**Re: Horsley Drive Business Park
 Fairfield Council Stormwater Queries**

Further to the recent State Significant Planning Submission at the above project address, we hereby provide the following response to comments from Fairfield City Council contained in a memo titled “*Comments on Horsley Drive Business Park – Costin Roe Consulting Civil Engineering Report by Catchment Management Branch*”, dated 18 September 2012.

**CIVIL ENGINEERING REPORT
HORSLEY DRIVE BUSINESS PARK
DEVELOPMENT APPLICATION**

OVERLAND FLOW CHANNEL CALCULATIONS

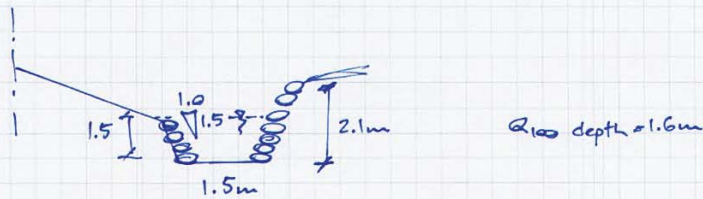
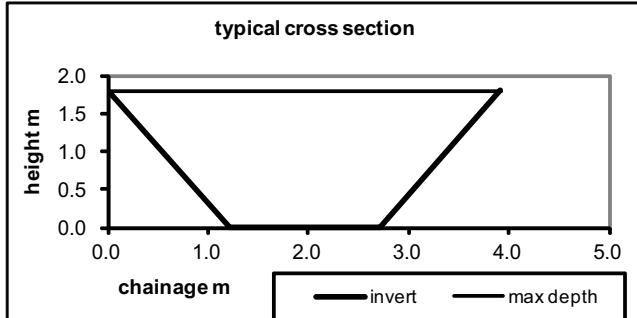
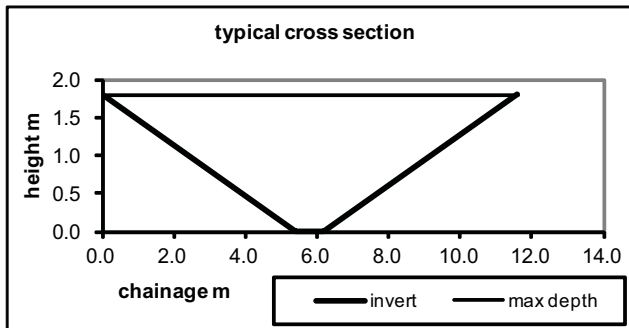
<p><u>Response</u></p> <p>Wording in report has been adjusted – refer to updated report, Revision B.</p>
5.4	14	<p><i>Need to ensure that there is sufficient grade on the overland channel around northern extent of the development. Please provide calculations undertaken to ensure the channel is sufficient.</i></p> <p><u>Response</u></p> <p>We confirm there is sufficient capacity in the channel to convey the Q100 peak flow of 3.45m³/s. Refer enclosed preliminary Mannings calculations for the flow path. Note that the flow path will be further assessed during detail design stage to ensure the adopted cross section and profile will be suitable for the re-routed overland flow path.</p> <p>Refer Appendix A of this letter.</p>

Q_{100} Peak Flow = $3.45 \text{ m}^3/\text{s}$

Channel Slope = 0.5%

Manning $n = 0.07$

COWPASTURE ROAD “BASIN” STAGE STORAGE RELATIONSHIP

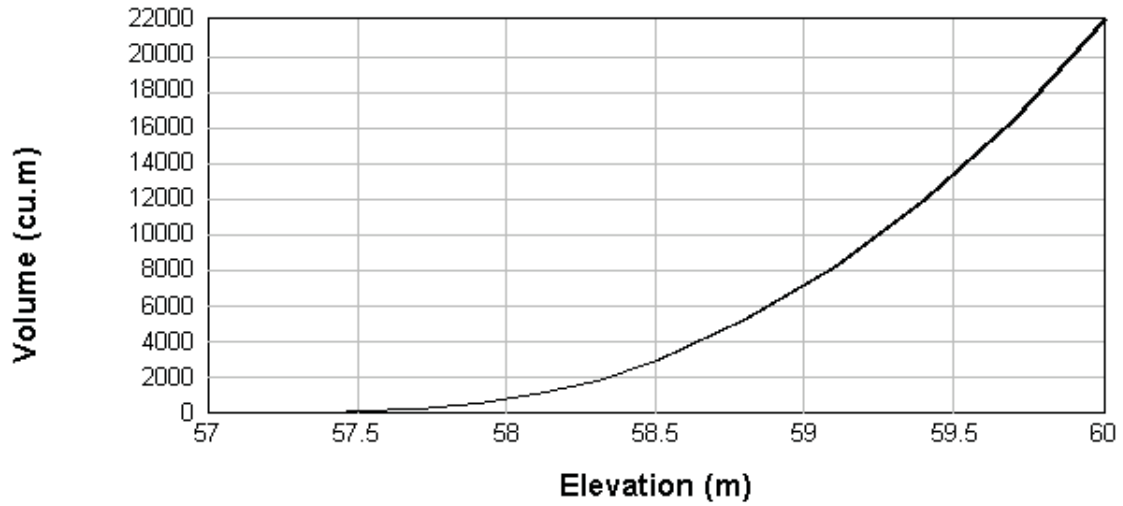
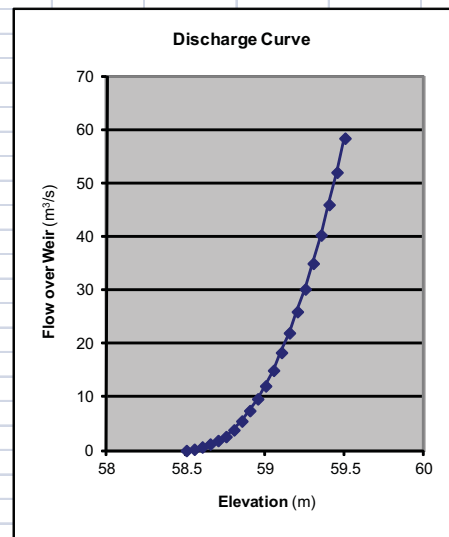
5.5	15	<p><i>What stage storage relationship was used for the two basins?</i></p> <p><u>Response</u></p> <p>Refer to Appendix B of this report.</p>

5.5	15	<p><i>What are the characteristics of the Cowpasture Road broad-crested weir</i></p> <p><u>Response</u></p> <p>The discharge characteristics of the Cowpasture Road were modeled as a series of weirs whose overtopping level increased in 250mm increments.</p> <p>Refer to Appendix B of this report for calculations.</p>

COWPASTURE ROAD WEIR STAGE DISCHARGE RELATIONSHIP
